N4860A-01

S E R V I C E N O T E

N4860A Digital RF Stimulus Probe

Installation of spacer to eliminate grinding fan noise

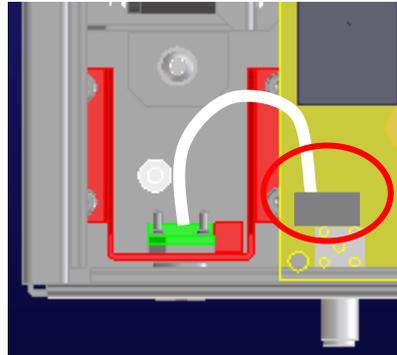
Some units exhibit a mechanical fan noise after shipping/transportation. The root cause of this issue is that the clearance for the fan assembly did not allow for worst case parts tolerances. On the defective units it is likely that the mechanical tolerances of parts allowed for the fan cable to slide out of its routing cavity onto the top of the fan housing during shipment. The cable sliding out of position put extra pressure on the fan housing, causing the deflection of the fan housing that interferes with the rotation of the fan blades.

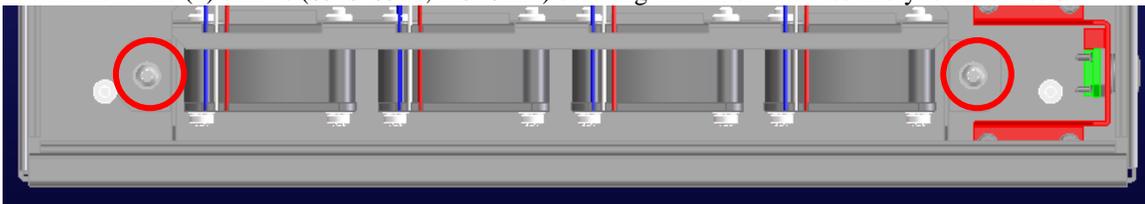
1. Remove the (4) cover screws (0515-0372, M3x8mm). *Set aside for re-use.*
2. Remove the cover
3. Remove the (4) hex stand-off hardware (0380-1631 M3x16mm) securing the PCA into the chassis. *This hex stand-off hardware will be replaced with new hardware upon re-build.*
4. Remove the remaining (5) screws (0515-0372, M3x8mm) securing the PCA into the chassis. *Set aside for re-use.*
5. Unplug power connector cable from PCA

6. Remove PCA
7. Remove the (2) screws (0515-0372, M3x8mm) securing the fan bracket assembly to the chassis

8. Remove the fan bracket.
9. Add the (2) washers (3050-2249, 6mm OD, .5mm thick) to the chassis stand-off and replace the fan bracket assembly – effectively lifting the fan bracket assembly .5mm higher in the chassis.

10. Secure the fan bracket into place with the original (2) screws (0515-0372, M3x8mm).
11. Re-Install the PCA, secure it with the original (5) screws (0515-0372, M3x8mm).
12. Re-connect the power connector to PCA.
13. Install (4) new hex stand-offs (0380-0298).
14. Re-install cover and secure with 4 screws (0515-0372, M3x8mm)
